Monitoring Report- Year 4
FINAL VERSION
Pen Dell Mitigation Project
Calendar Year of Data Collection: 2021

NCDEQ DMS Project Identification # 97079
NCDEQ DMS Contract # 6824
Neuse River Basin (Cataloging Unit 03020201)
USACE Action ID Number: SAW-2016-00885
NCDEQ DWR Project # 2016-0403 V2
Johnston County, NC
Contracted Under RFP # 16-006477
Data Collection Period: September 2020
Submission Date: October 20th, 2021

RE: WLS Responses to NCDEQ DMS Review Comments for Task 10 Draft Monitoring Report Year 4 for the Pen Dell Mitigation Project, NCDEQ DMS Full-Delivery Project ID #97079, Contract #006824, Neuse River Basin, Cataloging Unit 03020201, Johnston County, NC

Pen Dell
Figure 3: Pebble Count

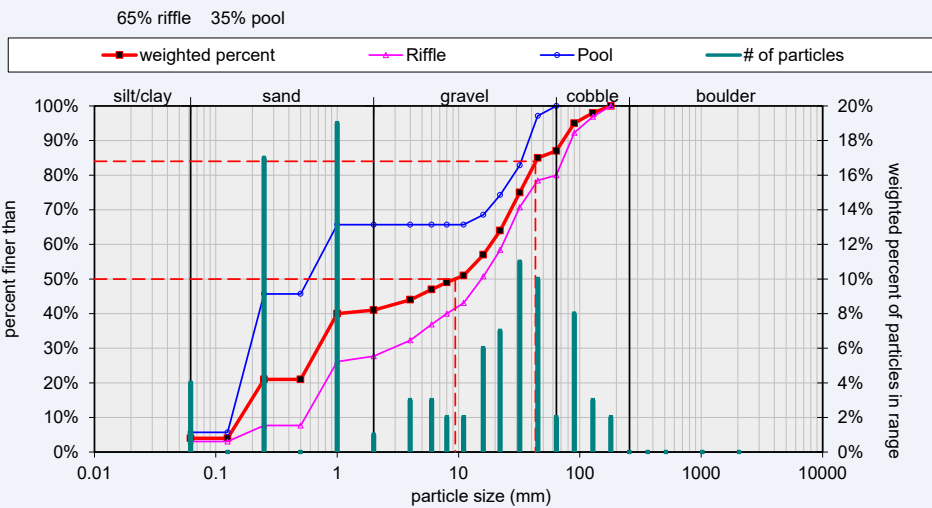
- 3. DMS Comment: Clarify in the text where the substrate samples were taken (which reach).** WLS Response: Language was added to clarify the location of the substrate samples. Near station 51+00 on R4.

Figure 5: Monthly Rainfall Data
Pen Dell Mitigation Project (NCDEQ DMS Project ID# 97079)
MY4 2021

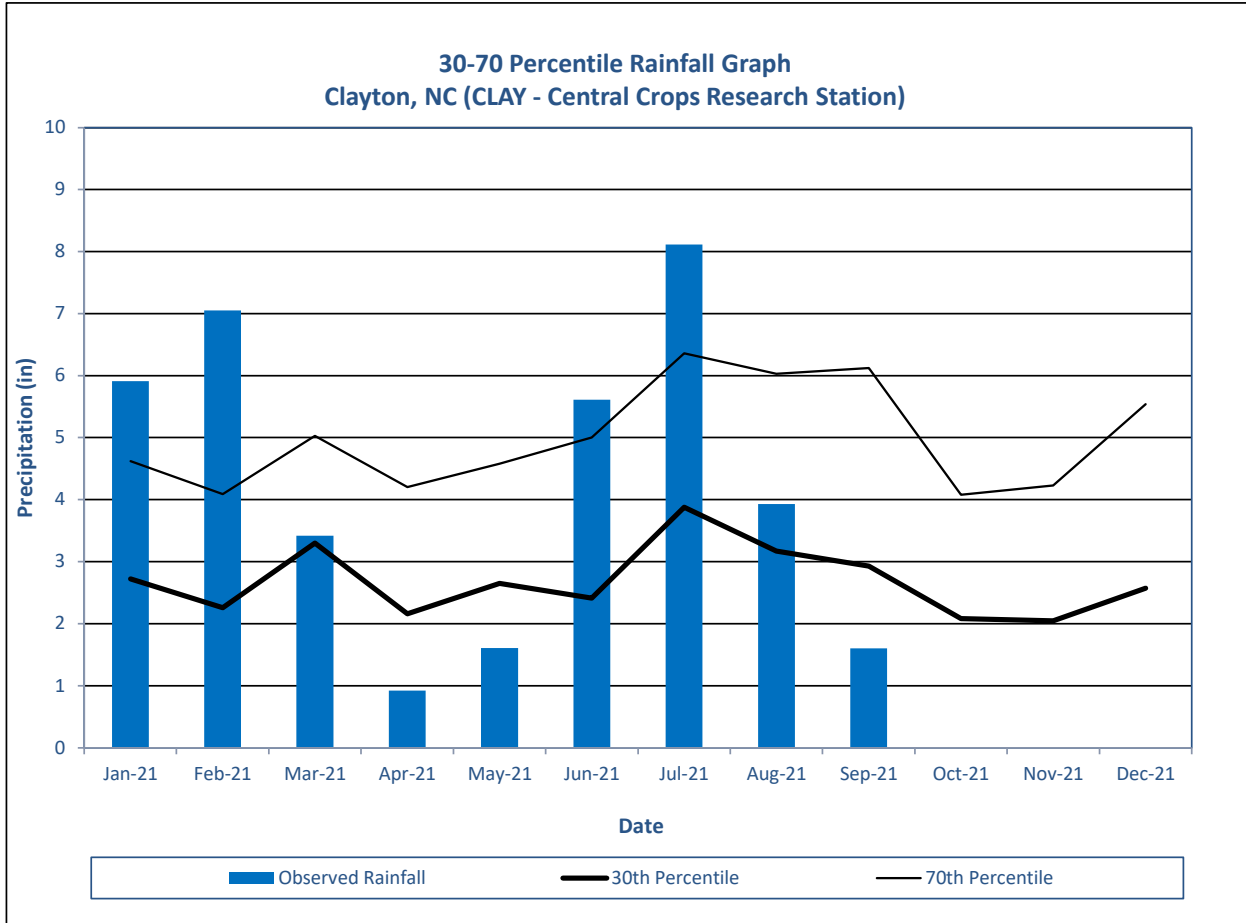
- 4. DMS Comment: Update rain report for additional months if possible.** WLS Response: September rainfall data was added to Figure 5.
